**RE: Architectural Design Review for Channel 9, Willoughby, Major Project Application
MP10_0198 (DoPI 2013/173)**

**RE: Architectural Design Review for Channel 9, Willoughby, Major Project Application
(DoPI 2013/173)**

Subject Channel 9 Site - Arup Response to PPR

Figure 1: Proposed Concept

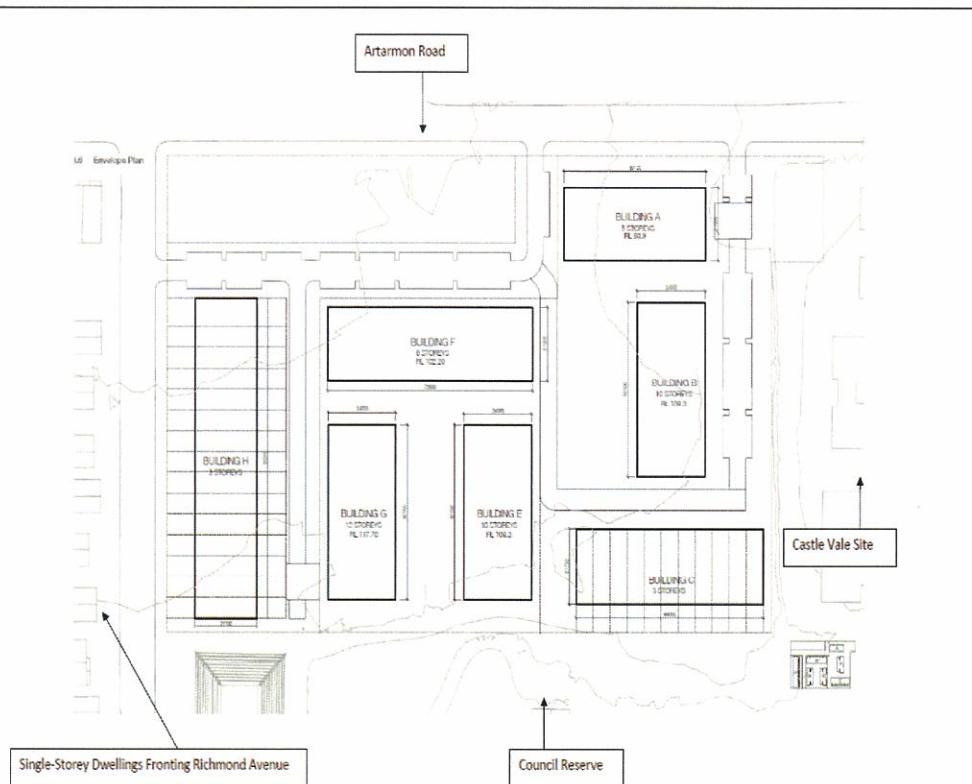
The department considers that the siting of the abovementioned building envelopes will provide an appropriate transition between the taller envelopes proposed in the central portion of the site, and the low, medium and high development adjacent to the site. Specifically the department is satisfied that:

- The five-storey envelope proposed for Building A has been sited to provide an appropriate transition between the taller buildings in the centre of the site (Buildings G, E and F) and the height, bulk and scale of the buildings on the adjoining Castle Vale site. In addition, the department considers that the height of the proposed envelope will not dominate the two-storey dwellings located on the northern side of Artarmon Road given that the northern side of Artarmon Road is significantly elevated. In addition, the 16 m wide landscape buffer proposed adjacent to Artarmon Road responds to the existing street setbacks and will soften the bulk and scale of the future buildings.

- The 10-storey envelope proposed for Building B will be partially screened by Building A when viewed from the areas north of the site. In addition, the envelope provides an appropriate response to the bulk and scale of the Castle Vale development located immediately east of the site. Notwithstanding, in order to ensure the future building does not overshadow the buildings located to the south of the site, the department has recommended a modification requiring this envelope to step down to the south of the site.

- The three-storey building envelope proposed for Building C will be comprised of terrace style dwellings to respond to the character of the two and three-storey attached dwellings located south-east of the site. Whilst the department is satisfied that the proposed envelope is generally compatible with the scale of the adjoining development, the department has recommended modifications to this envelope to reduce the impacts of overshadowing on the adjoining properties to the south.

- The 10 to 12-storey envelopes proposed for Buildings E, F and G are generally of an appropriate scale, however, the department has recommended modifications to the building envelope for Buildings G and E to ensure appropriate setbacks are provided to enable the retention of existing trees on site/facilitate the planting of substantial trees to soften the future buildings when viewed from the south.

- The three-storey envelope proposed for Building H will provide an appropriate transition down to the single-storey dwellings located on the western side of Richmond Avenue. It is proposed that Building H will be comprised of terrace style dwellings to provide a sympathetic response to the scale and character of Richmond Avenue. In addition, this building envelope is set back 10 m from the site boundary to

Figure 1 Proposed Willoughby Road / Artarmon Road Intersection Upgrade

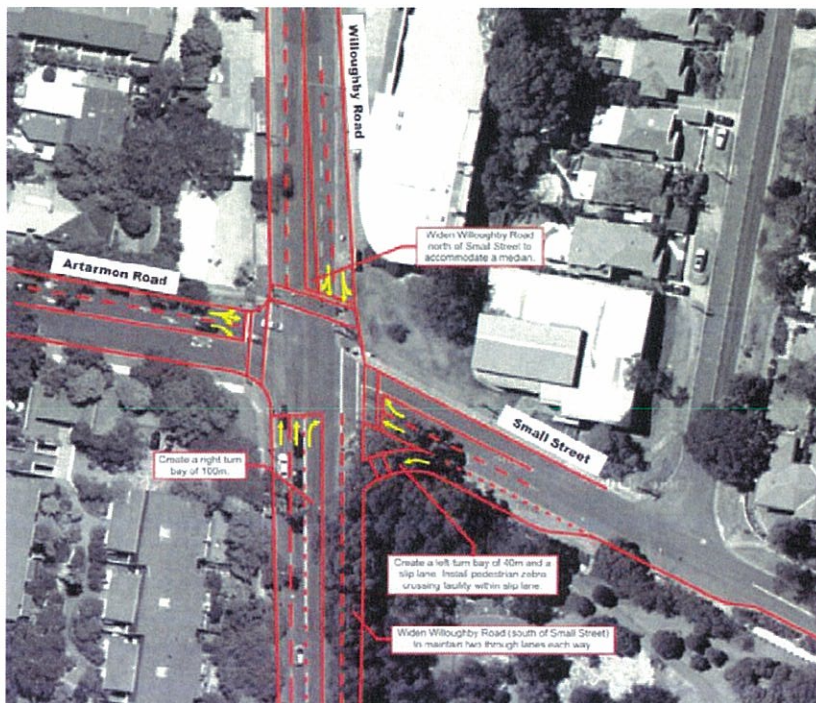
The July 2013 assessment prepared by Arup concluded the key constraint on the existing road network is during the Saturday peak hour at the Willoughby Road / Artarmon Road intersection. Based on the results of traffic modelling for the future Saturday peak hour, it was proposed that the intersection be upgraded as shown in Figure 1.

As the intersection already operates at capacity on a Saturday morning, it's performance is sensitive to any increase in traffic. The modelling forecasts the intersection to operate at Level of Service E during the Saturday peak hour, a deterioration from existing levels but an improvement from the previous analysis.

Based on the revised analysis, the intersection upgrade previously recommended (as per Figure 1) as a component of the Concept Plan approvals can no longer be supported. This is predominantly due to the reduced traffic impacts from the 450 dwellings proposed on the Channel 9 site. Additionally, some of the traffic impacts at this intersection are the result of the future expansion of the Willoughby Leisure Centre – the timing and scale of which is currently uncertain.

It is recommended that, prior to the development of 200 dwellings on the Concept Plan site¹, revised traffic counts and modelling be undertaken at this intersection during a weekday AM/PM peak hour, as well as a Saturday morning during netball season. Should the modelling indicate the intersection to be operating at an unsatisfactory level of service (F), the developer should initiate discussions with the RMS and Willoughby Council to facilitate the upgrade of this intersection.
